2.40 Joan Ruderman

Re: "Estates Reservoir Replacement / Draft Environmental Impact Report"
Subject: Improving the view of the Bay

Projects with the Potential for Cumulative Impacts
Revised Figure 5-1

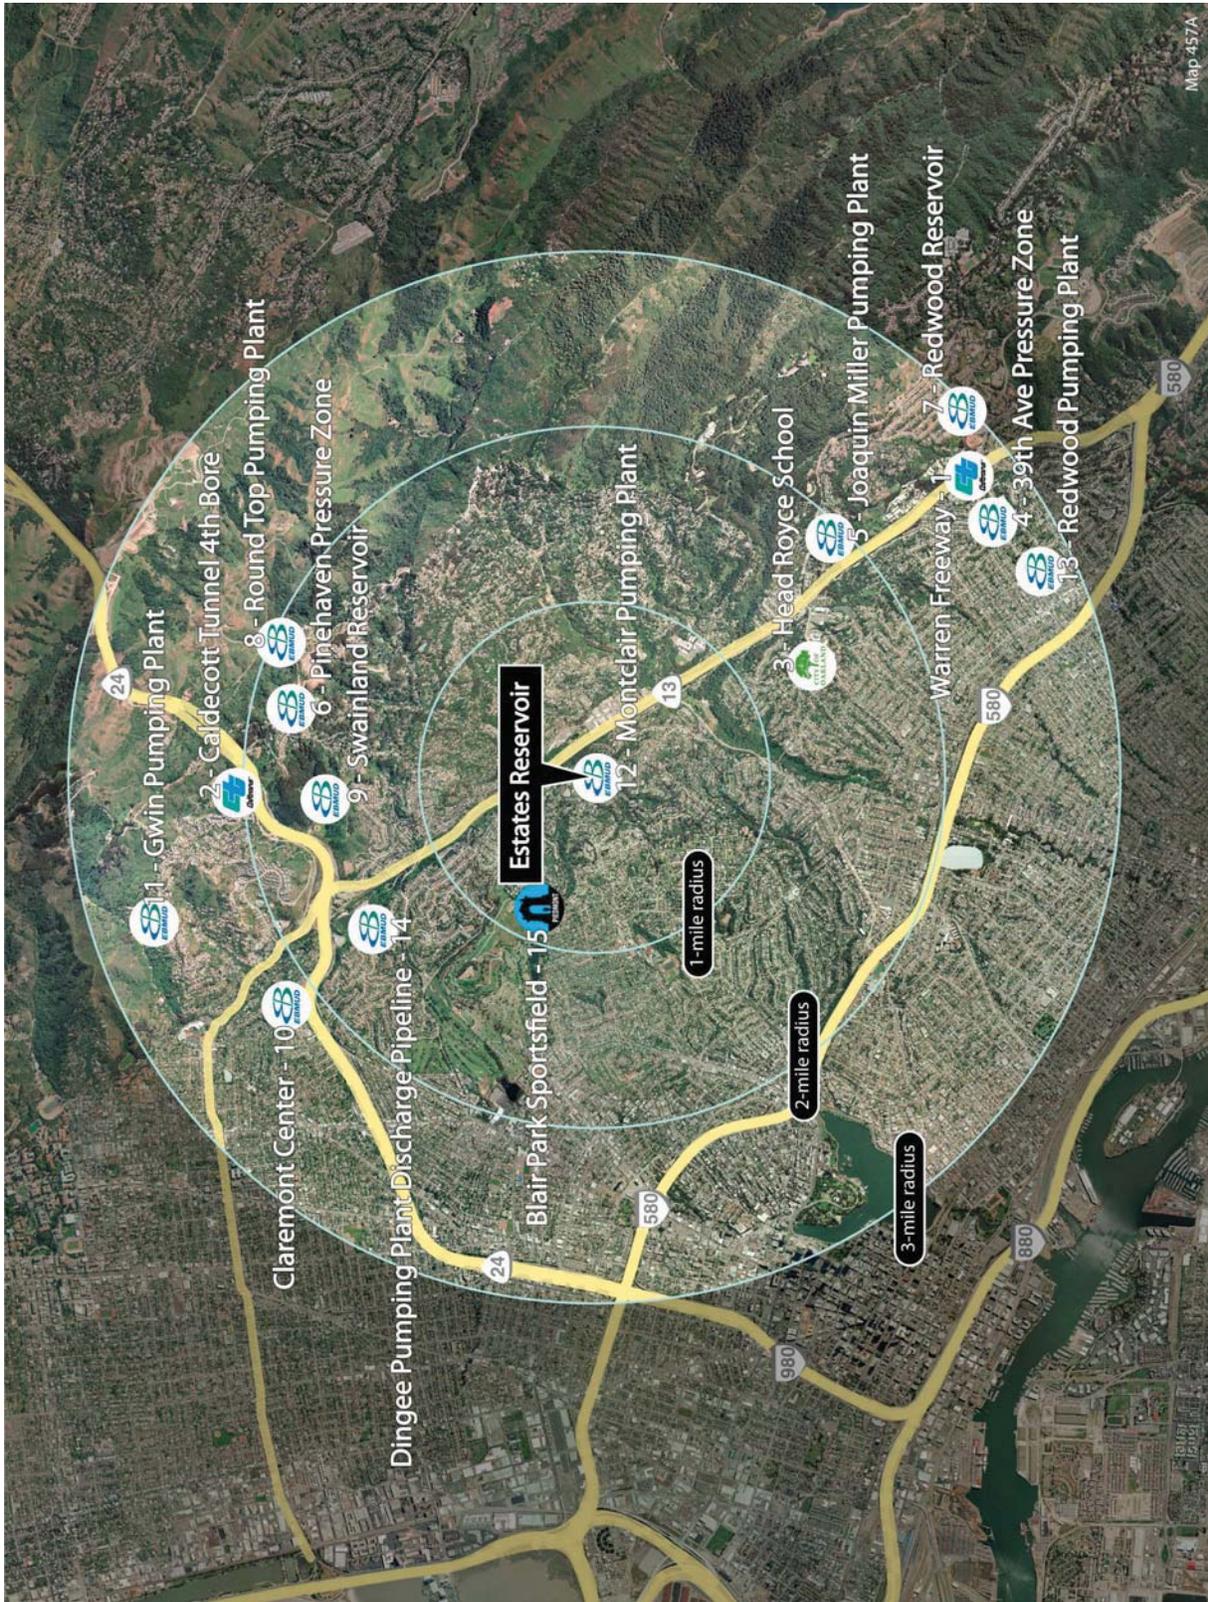
provided for these projects. In December 2008, the City of Piedmont approved combining the Blair Park Sportsfield and Coaches Field Synthetic Turf and Lighting Projects, and in September 2009 the City Council outlined an EIR process which would assume EIR certification in mid 2010. Construction would likely follow within the same time frame as the construction schedule for the Estates Reservoir Replacement Project (2011-2013). The Blair Park Sportsfield/Coaches Field Synthetic Turf and Lighting Project is within the three mile radius of the Estates site as shown on modified Figure 5-1, and is therefore added to the projects considered as having a potential for cumulative impacts.

Section 5.1.2, page 5-4, Table 5-1 is revised to include the City of Piedmont Blair Park Sportsfield and Coaches Field Synthetic Turf and Lighting Project, see item number 15.

Section 5.1.2, page 5-5, Figure 5-1 is also modified to include the City of Piedmont Blair Park Project which is within a one-mile radius of the Estates Reservoir site.

As shown in **Figure 5.1**, ~~the potential for potential cumulative traffic impacts as a result of known projects is remote to non-existent since, with the exception of the Montclair Pumping Plant Upgrade, which is part of the proposed Project, as known projects are not located in proximity of the site. However, there could be a significant cumulative effect associated with the projects listed in Table 5.1 for State Routes 24 and 13, and Interstate 580.~~ there is a potential for cumulative traffic and circulation impact associated with construction of the City of Piedmont Blair Park Ballfield/Coaches Field Synthetic Turf and Lighting Project which is within a one mile radius of the Estates Reservoir site and which may have a construction schedule within the 2011-2013 time frame identified for the Estates project construction. The potential cumulative impact would be related to the City of Piedmont and EBMUD using Moraga Avenue, SR13, and Mountain Boulevard as construction traffic routes for their respective projects. The Estates Draft EIR identifies Moraga Avenue/ SR13 as the exit route for project construction traffic. As noted in the preceding paragraph, the Draft EIR has already identified potentially significant traffic and circulation impacts associated with these locations and provided mitigation measures to reduce potential impacts to a Less than Significant level (Mitigation Measure 3.6-1, page 3-6.19). It is incumbent upon the City of Piedmont to ensure that the EIR it prepares for the Ballfield Project considers the Estates Reservoir Project in its EIR analysis, since the Estates EIR will be certified well in advance of the City of Piedmont EIR for the Ballfield Project.
